Request for further information in accordance with section 92 of the Resource Management Act 1991

Notice of requirement: Eastern Busway EB2 (Auckland Transport)

Resource consents: Eastern Busway EB2
BUN60407133 LUC60407134 DIS60407135 (NES - FW)
DIS60407492 (Earthworks/Contamination)
CST60408360 (Occupation)
CST (Disturbance) – reference to be confirmed

Eastern Busway	Drawing Title FOR LODGEMENT	Design Package CIVIL AND GEOMETRICS
	Drawing No. 1820 0300 MOUNT SEEN CIRCUIT	Drawing Title TI RAKAU DRIVE EROSION CONTROL PLAN SHEET 5 OF 6
2016 NEW ZEALAND A1 1:500 A3 1:1000	Drawing Number EB-2-D-3-RD-SK-000014	Format A

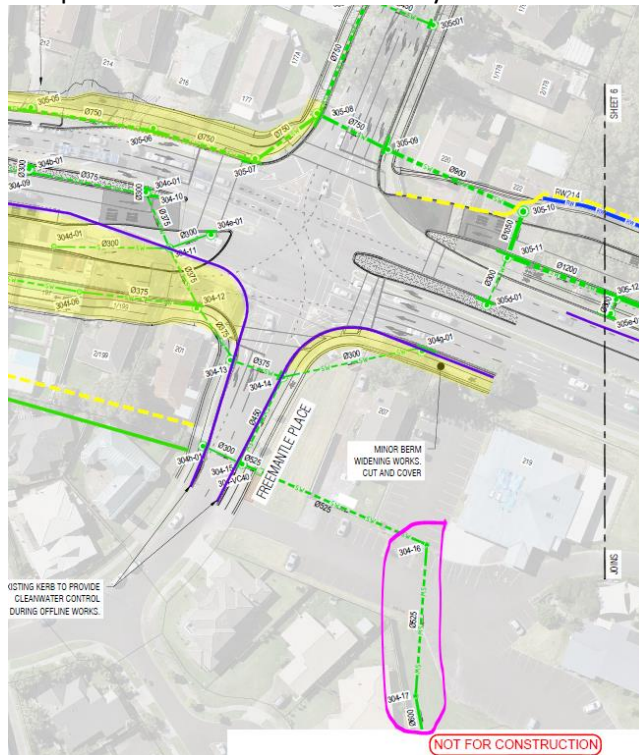
7 ESCP Drawing SK-000014 identifies a stormwater line directed to the south of the drawing (outlined in pink below). For avoidance of doubt, please clarify whether this stormwater line(s) and/or outfall will be upgraded as part of the proposed development. Please update the drawings and provide details where necessary.
